REQUEST FOR INFORMATION **DATE:** November 10, 2016 **NO.:** RFI-346

Project Name: 15051-Webster University Interdisciplinary Science Building

Subject: Additional detail for wire mold in room 283

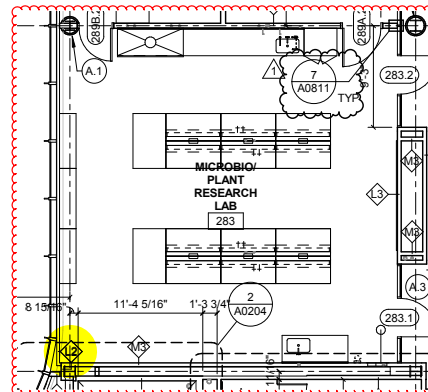
We are looking for additional details on the following questions;

1. How should the mullion mounted wire mold on the west wall in rm 283 be fed? Is the intent for the wire mold to extend to the column?
2. If the intent is to feed the wire mold via the columns what is the design intent for making the transition from the column to the wire mold?
3. The plans show the wire mold stopping between 2 mullions unsupported. Please confirm this is the intent or if the wire mold should stop at the next mullion for additional support.

There is a knee wall 'L2' behind the curtainwall spandrel. The intent is attach the wire mold to this wall and feed it through this wall.
